# BCA Assessment Report

Maitland Gaol Redevelopment  
Maitland NSW

Prepared for:  
Maitland City Council

Revision 3  
14 September 2023

Figure 9: Steel Columns to be Fire-rated

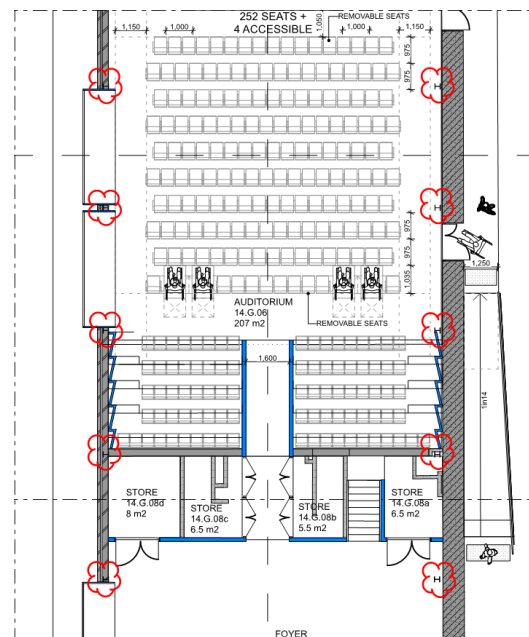
All load bearing steel columns and the like to be identified on plan for review. Fire rated required in accordance with BCA Spec 5 except where permitted variation is applied. Typical example below.

Figure 10

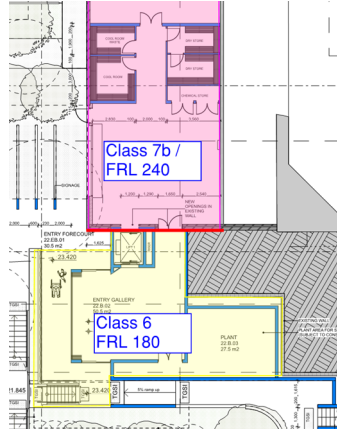
Basement storage to be fire separated from Class 6 by 240 minutes except where varied by FER. Fire separation also to bound out of scoped area to limit the extent of upgrade works required. This strategy will avoid unnecessary upgrade of existing structure.

Figure 22: Extended Travel from SOUs

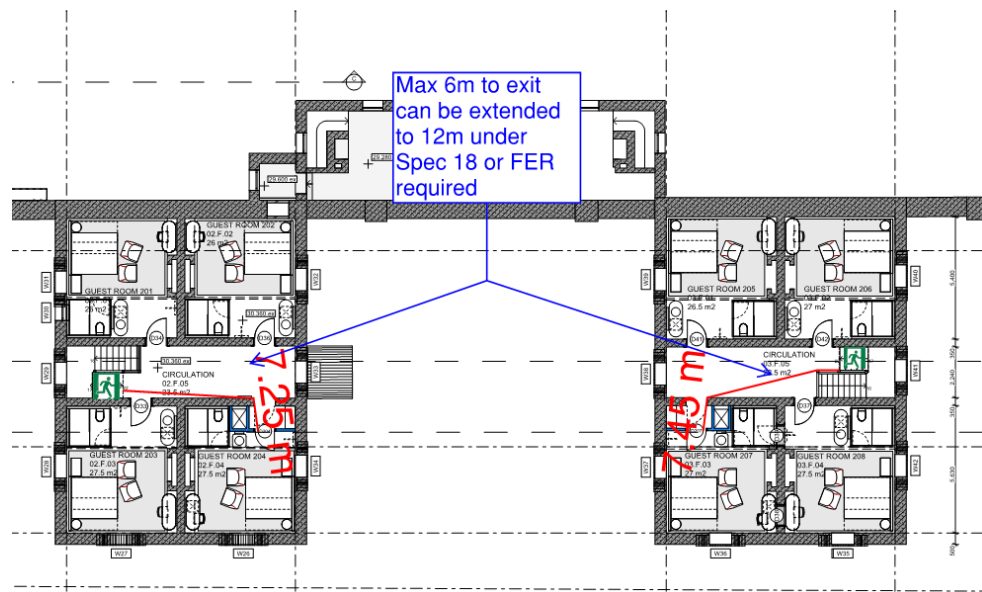
Accommodation building: The accommodation building exceeds 6m to an exit on basement and level 1 as required to D2D5 however this may be increased to 12m in accordance with Specification 18 concessions for AS2218 sprinkler protected building where compliance with S18C3 is achieved. Fire service designer to ensure compliance with Spec 18 is achieved.

Figure 23: Egress Width less than 1m

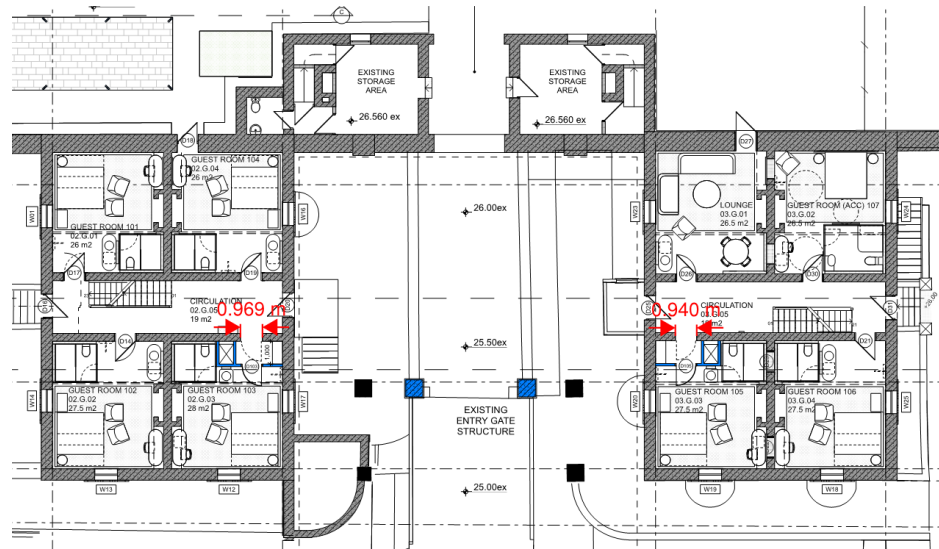
**Comment:** All areas other than entertainment venue parts to be minimum 1m clear unobstructed width. Accommodation building has a number of locations scaled less than this requiring design development. DDA consultant to confirm if second required handrail will be installed to stairs or Performance solution proposed as this will further require egress.

At the direction of the client, the below indicated doors have been reviewed as openings. Architectural documentation is to be updated to reflect design change.

**Performance Solution:** Where reduced egress widths are proposed in existing building <1m this is to be addressed under a Fire Engineered strategy to be addressed as part of the CC stage.

Figure 24: Fence/Gate along a Path of Egress

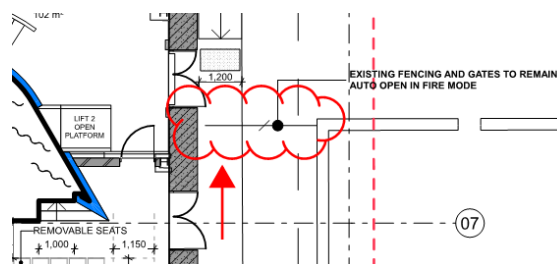
Additionally, the existing fencing and gates will need to be reviewed in future design stages to ensure an unobstructed width of 1.2m is maintained along the nominated path of egress.

Figure 26: Existing Gate at Exit Discharge

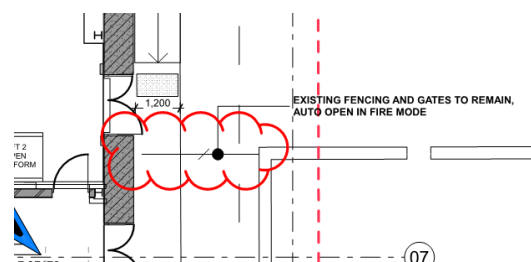
Architectural plans indicate that the existing gate highlighted in the figure below is to be provided with auto-unlatch/auto-open on alarm. The unobstructed width of the egress path through the gate is to be confirmed on the architectural documentation.

*Figure 27: Enclosures located under non-fire isolated stairs*

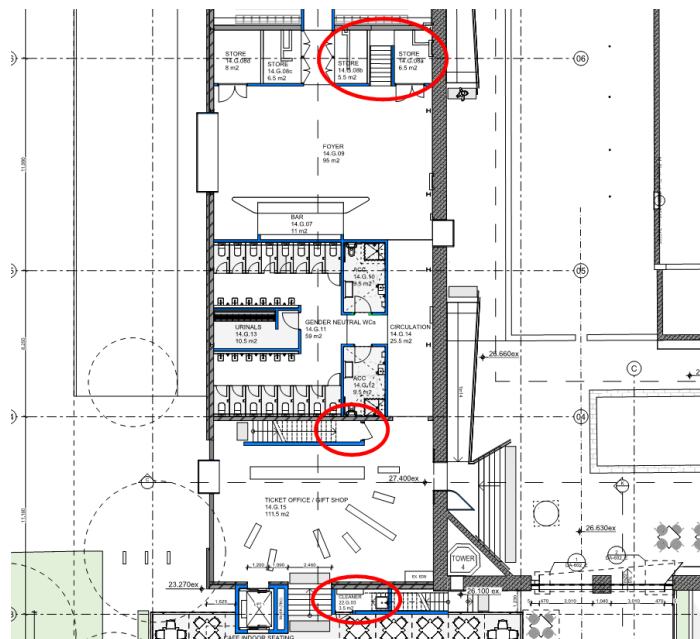
**Comment:** A number of non fire isolated stairs depict a cupboard or enclosure under the stairs required fire separation in accordance with the requirements of this Clause. Architect to depict all enclosures under stairs with FRL 60 minutes separation with self closing -/60/30 fire door.

See E1D3 for FHR not permitted to pass through fire doors requiring FER for coverage.

Figure 30: Handrails to be included

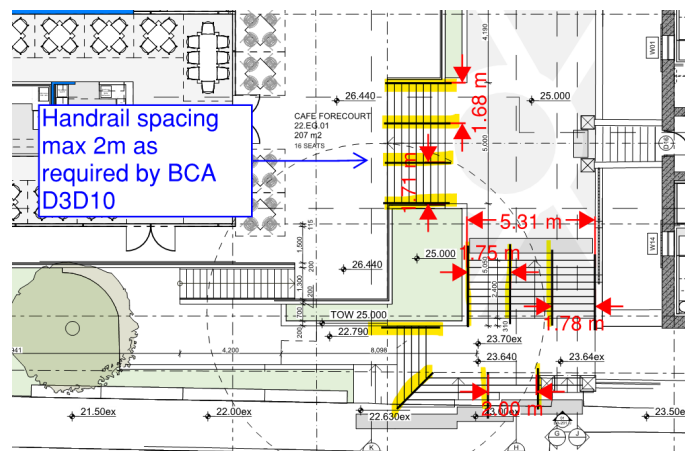
Stairs required for aggregate egress require handrails <2m spacing where required for aggregate egress. Typical example below, DDA consultant to ensure this is developed into design in accordance with AS1428.1.

Figure 31: Stairways and Ramps requiring Two Handrails

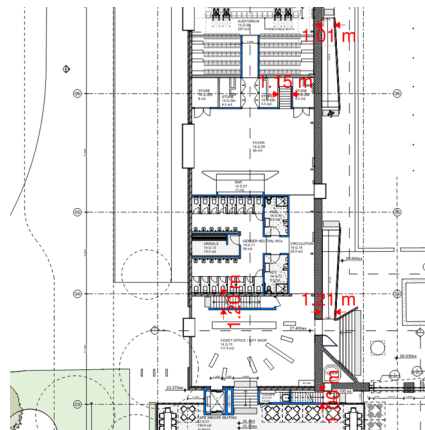
Stairs typically shall ensure minimum 1m clear unobstructed width between 2 x handrails. Architect to depict clear 1m between 2 x handrails on all stairs and ramps in accordance with AS1428.1.

Figure 32: Area of Stage, BOH and Green Room

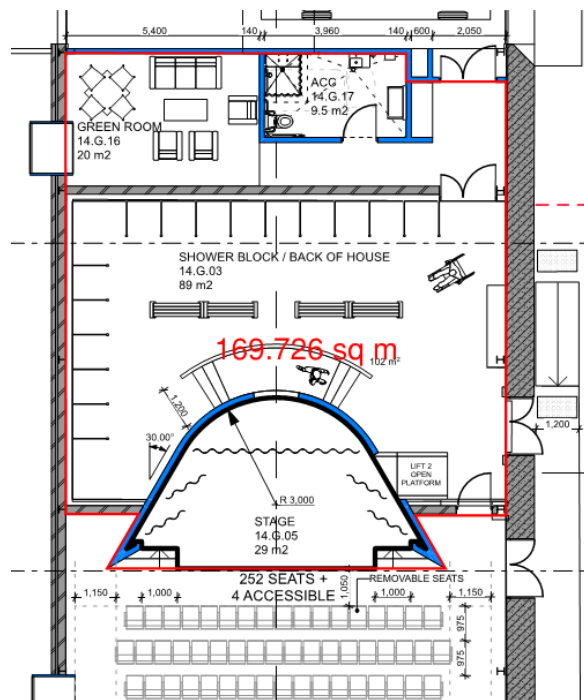
The architectural plans depict stage and back stage area in excess of 150m<sup>2</sup> (approx. 171m<sup>2</sup>) which would therefore require smoke exhaust system in accordance with NSW E2D16 (c)3.

Figure 33: Separation of Back of House and Green Room

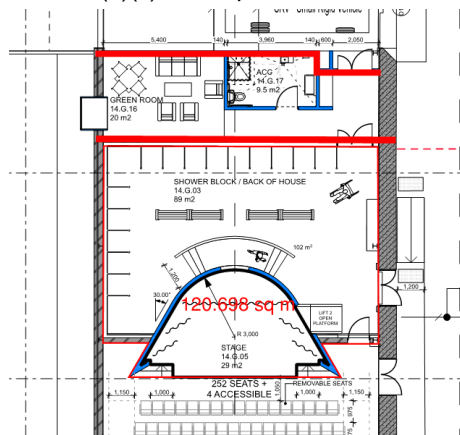
Where separation (FRL 60 minutes) of greenroom/ back of house reduces floor area between 50m<sup>2</sup>-150m<sup>2</sup> than roof mounted automatic smoke and heat vents complying with NSW I4D59 could be considered by way of fire engineered strategy as there is roof directly above however this is not the uppermost storey (NSW E2D16 (c)(ii)). Example below.

Figure 34: Proposed Sanitary Facilities

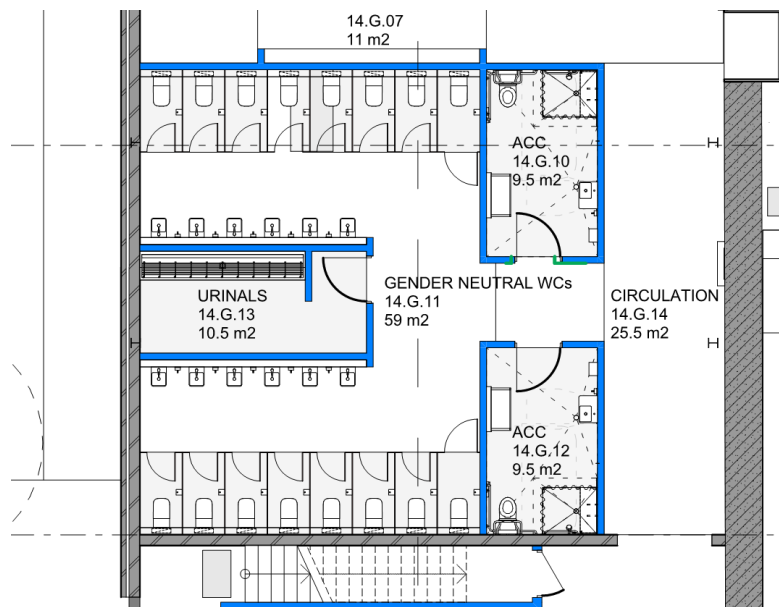
Architectural plans depict gender neutral WC's. F4D3 and F4D4 require sperate facilities for males and females. Gender neutral facilities do not comply in this regard.

**Performance Solution:** A performance solution will be required to address any non-compliance with the Performance Requirements. This is to be agreed upon by relevant stakeholders including Principal Certifying Authority.

Figure 36

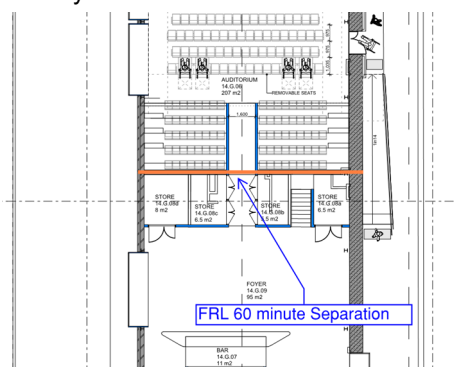
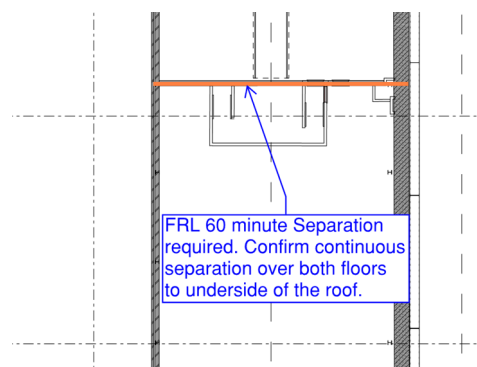
**Comment:** Confirm separation on plan example below. Note this would require to be separated in upper story as well.

Figure 38: Stage Area

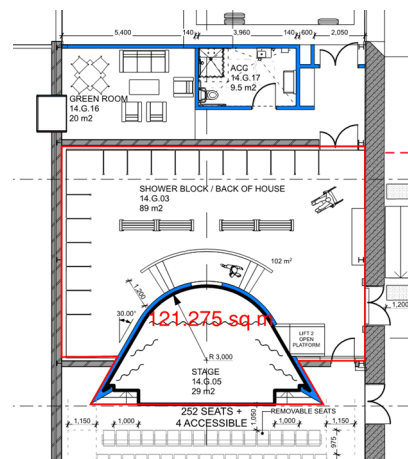
**Comment:** The stage and backstage areas are not currently fire separated and therefore (under the provisions of NSW I4D6) have an area greater the 50m<sup>2</sup> but less than 150m<sup>2</sup>.

**Comment:** In order to achieve compliance, both the stage and backstage areas are to be provided with 2 or more means of egress.

In this regard compliance is not currently achieved. There is potential for the curved stairs to be split and provide two separate egress points from the stage. Alternatively, can be addressed by way of a fire engineered solution.

Figure 39

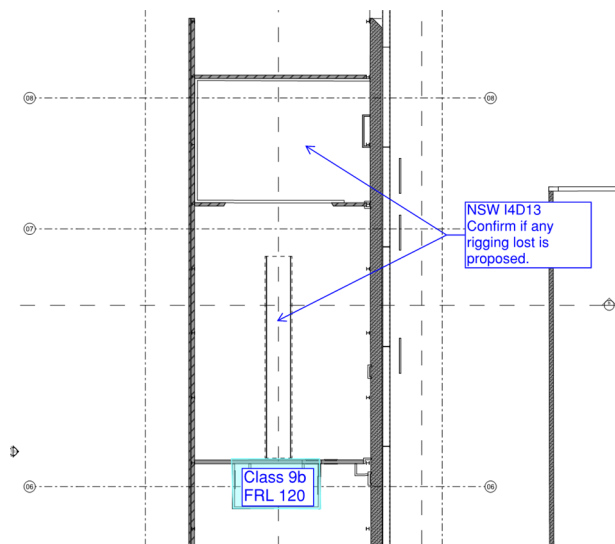
**Comment:** It is noted there is an elevated platform however this is not located above the stage but rather set back. Confirmation of use is required and if there is any grid or flying scenery located over the stage to which the provisions of this Clause will apply.
